Instructions to modify the Pulse Line from internal (IPL) to external (EPL).

# SERVICE BULLETIN – ATOM80

Update of the carburettor pulse-line system

1P04-0020\_01 - External pulse line upgrade kit

4.

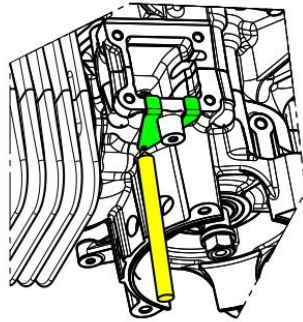
Position the drilling tool as indicated

7.

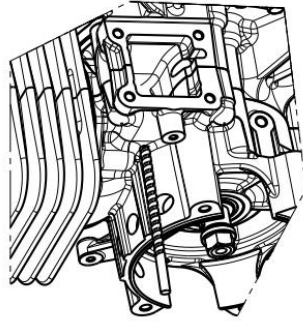
Drill with the bit provided in kit Ø4.6

9.

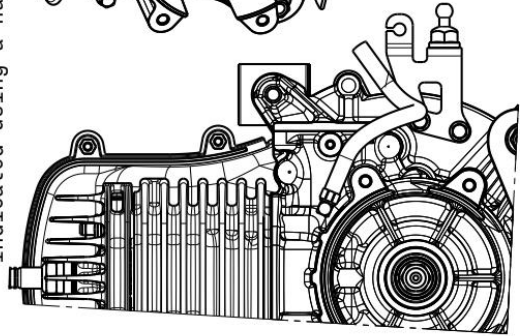
Assemble the fitting + tube as indicated using a hammer.

**11.** Drill the cover using the bit provided in the kit of  $\varnothing 4.6$

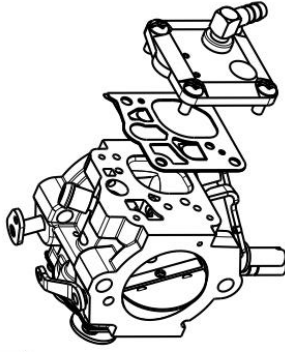
**12.** Assemble the fitting with Loctite 638

**13.** Replace the cover

**14.**

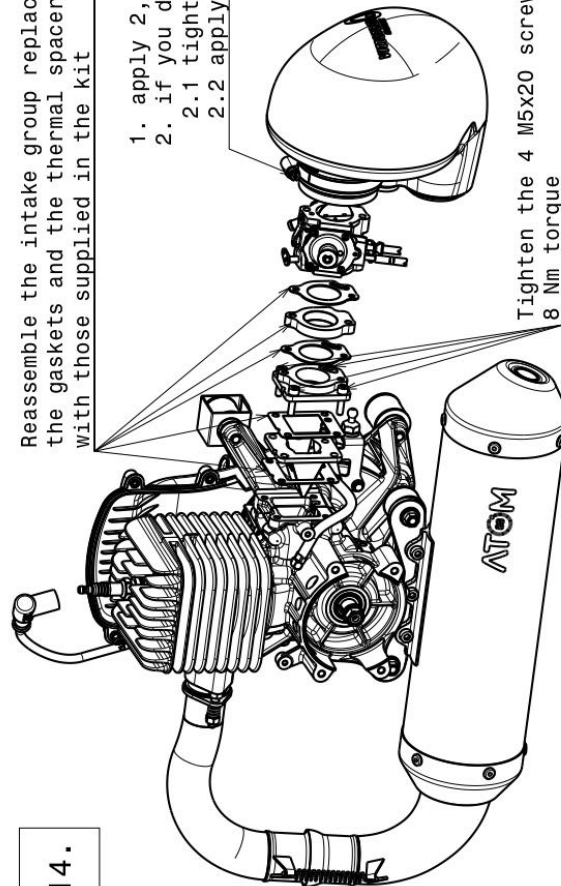
Reassemble the intake group replacing the gaskets and the thermal spacer with those supplied in the kit

1. apply 2,5 Nm torque
2. if you don't have a torque wrench
  - 2.1 tighten the hose clamp until it start squeezing the rubber
  - 2.2 apply 1 and  $\frac{1}{2}$  more complete turns

Tighten the 4 M5x20 screws with 8 Nm torque

Hook the hose to the fitting as shown

16.

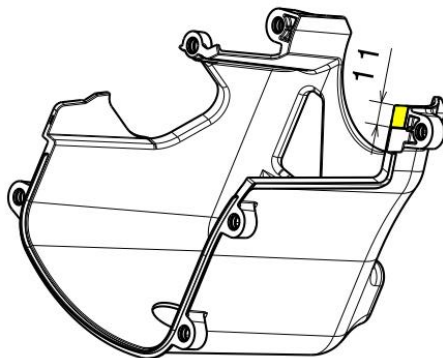
cut the conveyor as shown in the figure
